# CENTRAL EYRE IRON PROJECT

Environmental Impact Statement  
Response Document

**Figure 2: Model Output for Drawdown**

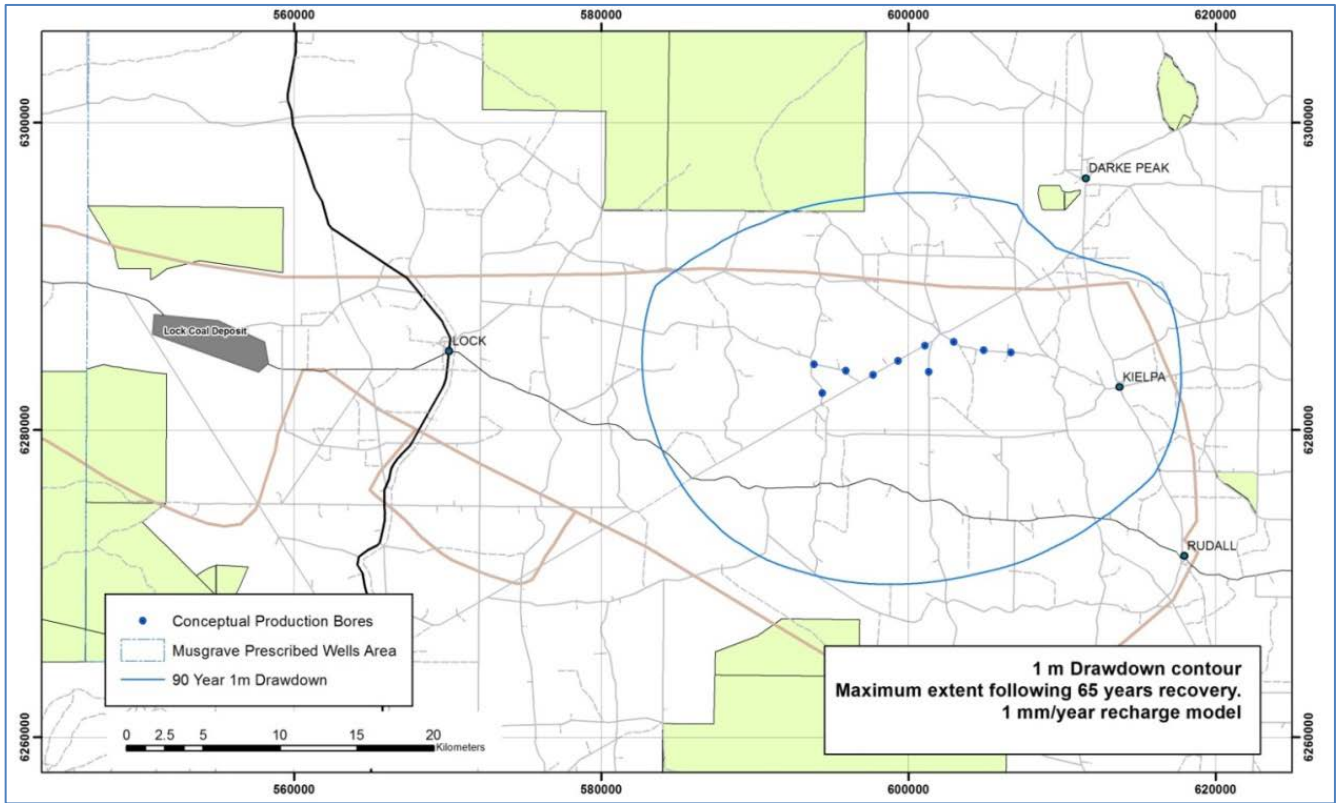
#### 4.3 DEWNR Comment # 37 - Appendix V

Provide additional information regarding the cone of depression and its possible extent following cessation of pumping.

Recovery of the groundwater system is simulated in the recovery models run as part of the sensitivity analysis. The results are summarised in Chapter 16.5.2 of the EIS with full details provided in the Groundwater Science Report *Kielpa Groundwater Supply Model Sensitivity Analysis E-F-66-RPT-2002*. Note that as this report contains information relating to costs it will be provided to SA Government on a commercial in confidence basis only, with no authorisation for it to be released or published as part of this Response Document.

Sensitivity analysis was undertaken for varying rates of recharge (1, 7, and 15 mm per year). Complete water level recovery is predicted between 350 years (1 mm recharge) and 75 years (15 mm recharge). Note that no recharge is applied in the pumping models presented in the EIS and GIA (for this reason these models are very conservative).

For the conservative (1mm recharge) model, the 1 m drawdown contour reaches its maximum extent following approximately 65 years recovery (the cone of depression flattens and extends following cessation of pumping, and then diminishes to nothing as recharge replaces the water previously removed through pumping). At 65 years the calculated 1 m drawdown contour is located 35.7 km east of the MPWA boundary. See Figure 2 below for model output.

Figure 3: Updated Mineral Resources for the CEIP

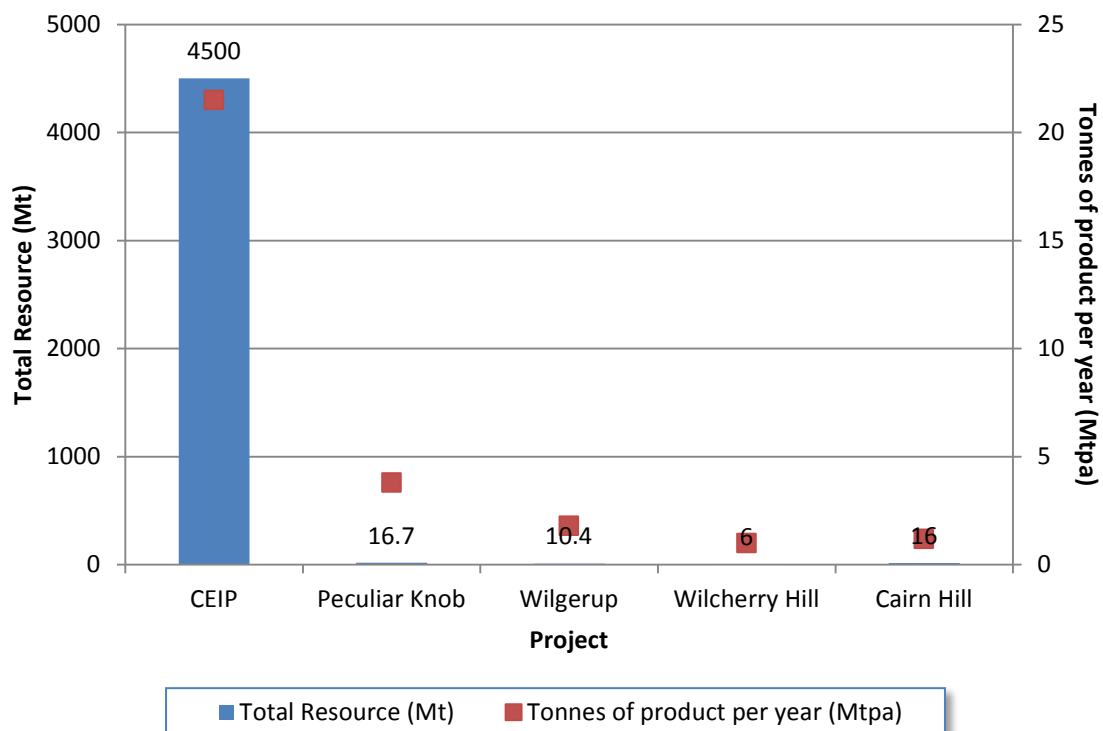
DEWNR Comment # 39 points out that Figure 1-1 within EIS Chapter 1 does not align with the information relating to the CEIP Mineral Resources provided elsewhere in that Chapter.

While Chapter 1.3 correctly advised that the Mineral Resources for the CEIP is 4.5 billion tonnes, up 819 million tonnes as a result of the Company's last drilling programme, completed in late 2014, Figure 1-1 showed only 3.7 Billion tonnes, the known Mineral Resources prior to that final drilling programme. Please refer to the updated Figure below which is consistent with the CEIP Mineral Resource of 4.5 billion tonnes.
